Reference: (1) License No. SNM-42, Docket 70-27

Subject: Revised Request to Amend License SNM-42, Chapter 5, *Nuclear Criticality Safety*

## **Summary of Requested Additional Information with BWXT Responses for Amendment Request for Chapter 5 of the SNM-42 License Application**

**Figure 1: Example of Additional Margin to Compensate for a Positive Bias**

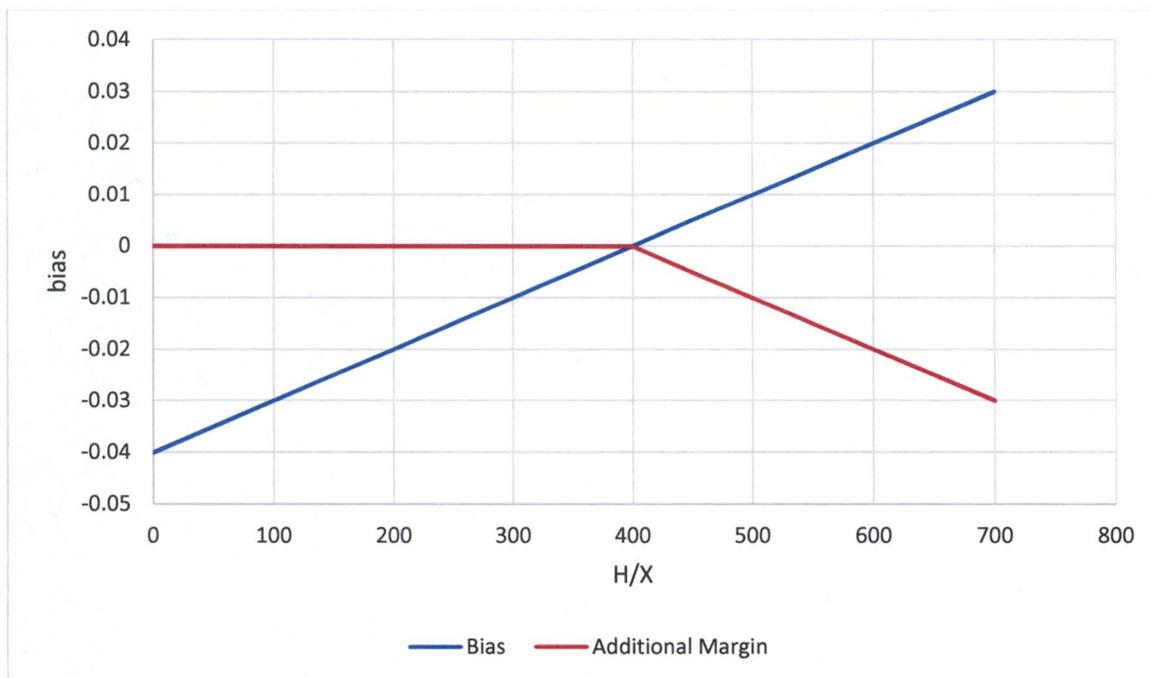
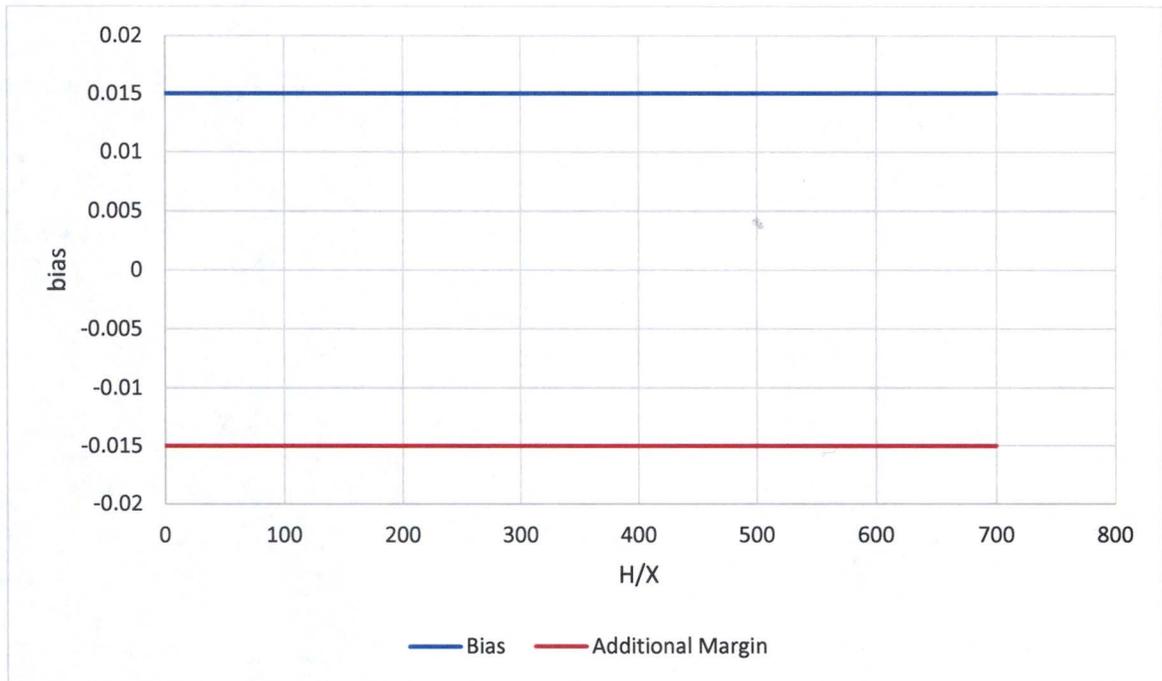
Describe the amount of margin that shall be applied to compensate for positive bias, in your discussion in LA Section 5.2.1. Your submittal states that additional margin will be applied sufficient to compensate for the positive region. As shown in Figure 1 of your submittal, this additional margin appears equal to the amount by which the trended k-effective value exceeds unity. LA Section 5.2.1 states that in such cases, additional margin shall be applied, but does not describe how much additional margin to apply.

The additional margin is applied to directly compensate for the positive bias. If a trending method is used for the bias, the additional margin will be a mirror image of the trending. A fictitious example is shown in Figure 1. In this case, the bias has a positive slope and becomes positive at  $H/X=400$ . At that point, additional margin would be added equal to the amount of positive bias as a function of  $H/X$ .

For methods that use average values for the bias, the additional margin would be equal to the positive bias as shown in Figure 2.

The additional margin will be applied to directly compensate for the positive bias. This is discussed in detail in the response to NRC Question 1.

**Figure 3: Partial Cut-Away of the Base Model and Base Model with Water Box Removed**

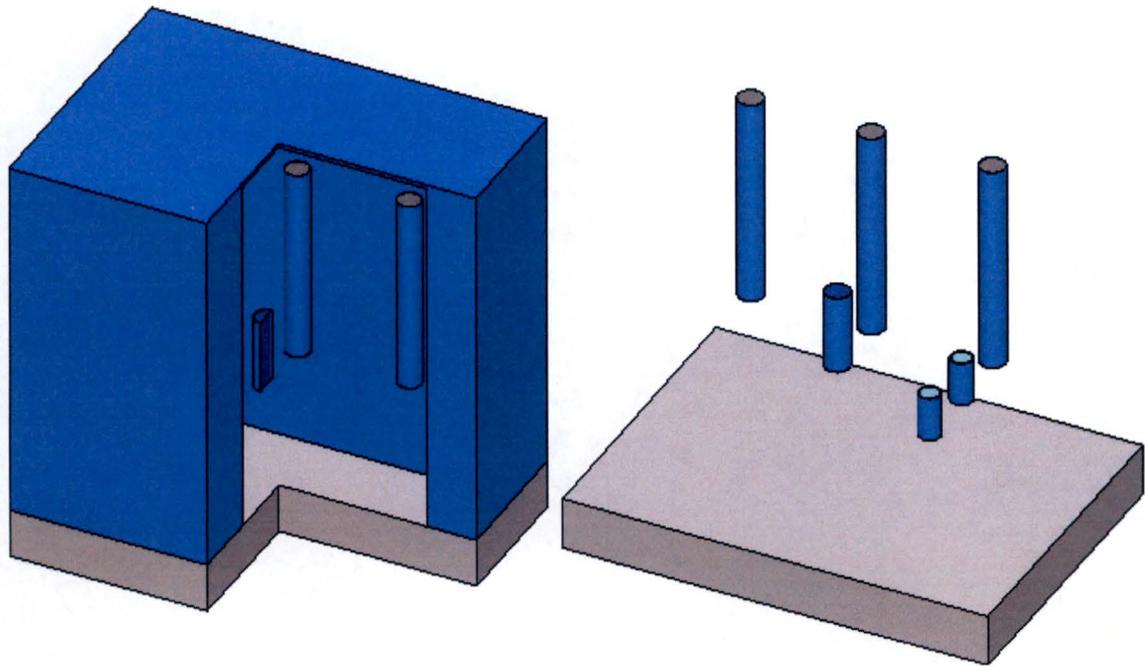
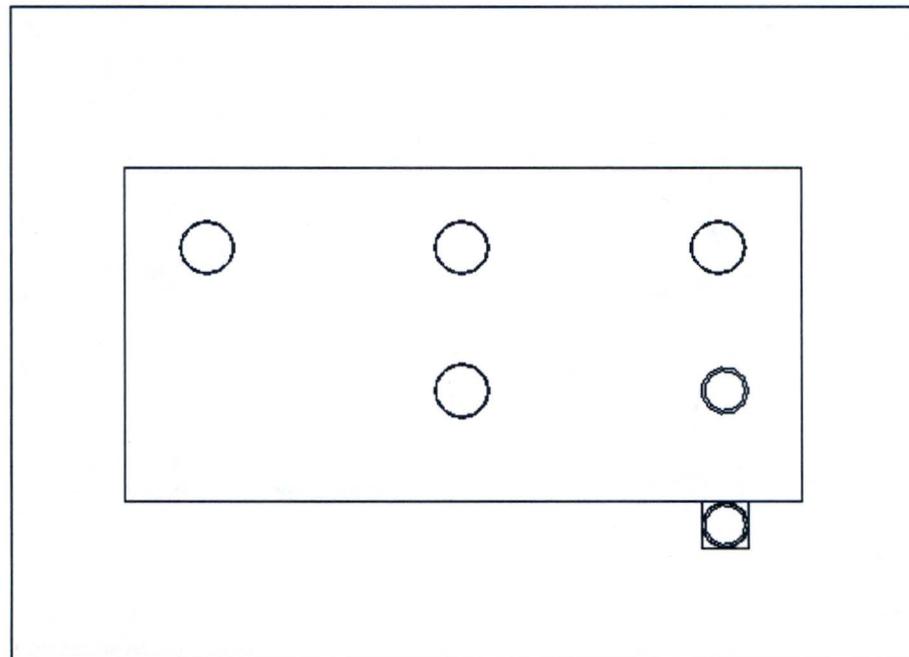
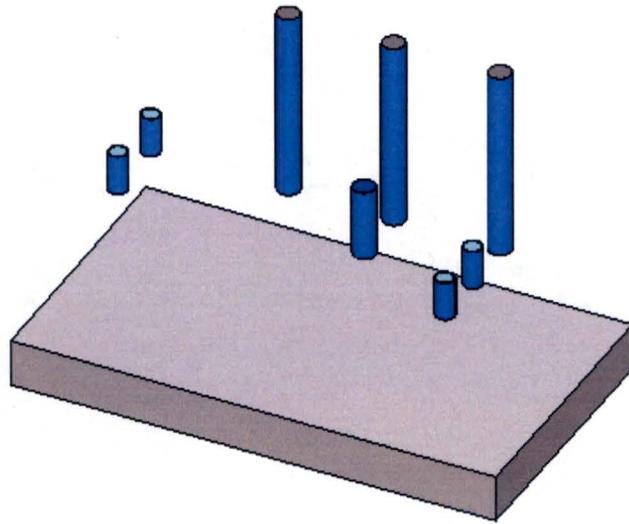
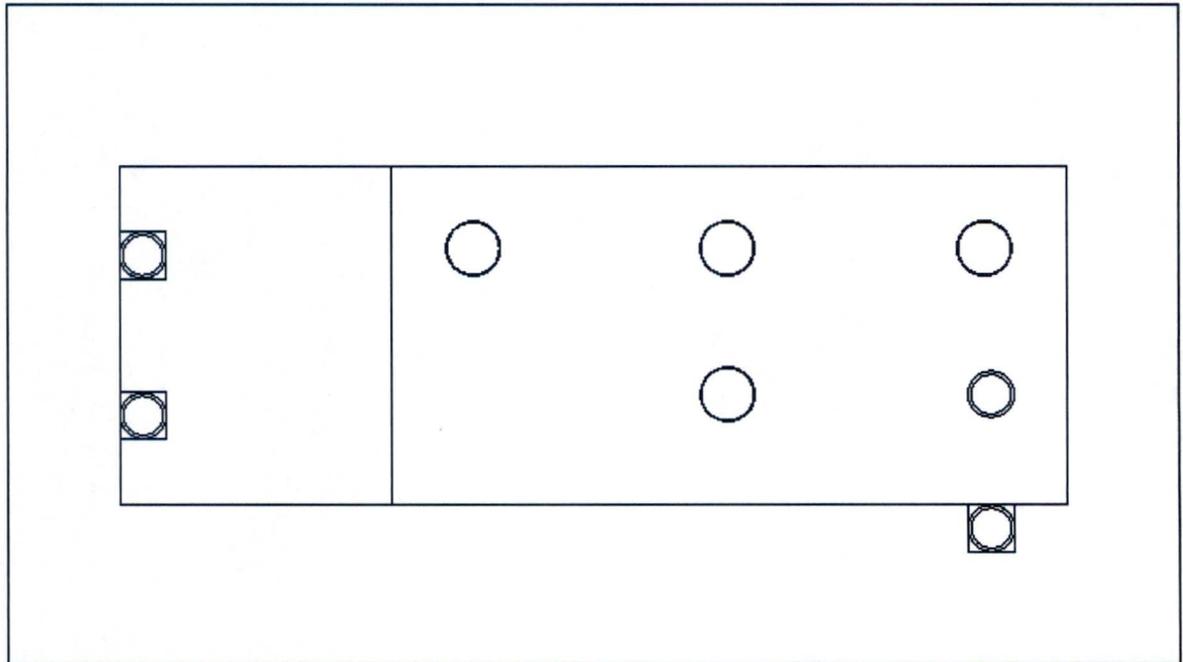
Provide an example of the assessment described in LA Section 5.2.2.4 (i.e., the assessment of the sufficiency of the water box to bound neutron interaction). Describe in

detail the models used in performing this comparison (e.g., base model, model with the water box, model with interacting units).

As an example of the method, a fictitious system was created. It is a uranium metal dissolver glove box. The base model is described below followed by the interaction model.

The glove box is 6 feet long by 3 feet deep by 5 feet tall. There are three 5 inch diameter by 4 foot tall solution columns in the back of the glove box. The columns are 27.2 inches on center and the columns are 6 inches from the back and sides of the glove box. There is a 5 inch diameter by 18 inch tall dissolver column centered right to left and is 9 inches from the front of the glove box. There is a can of uranium metal placed in a holder to the right of the dissolver. In the front of the box there is an in-transit can of uranium metal. The floor of the box is 30 inches off the floor, see Figure 3 and Figure 4.

The columns and dissolver are modeled with a water film and the cans are modeled with a hand wrap. The lateral sides are wrapped in at least 12 inches of water and there is 1 inch of water on the top of the box.

The interacting model involves adding the storage location to the left of the glove box. These cans are the same as the cans in the original model. The cans are located on a rack that provides 2 feet spacing from the glove box and 12 inches between cans on the rack. The rack has two positions. The left side of the base model is modified to place the 12 inch water reflector outside the cans on the rack, but in contact with the cans, see Figure 5 and Figure 6.
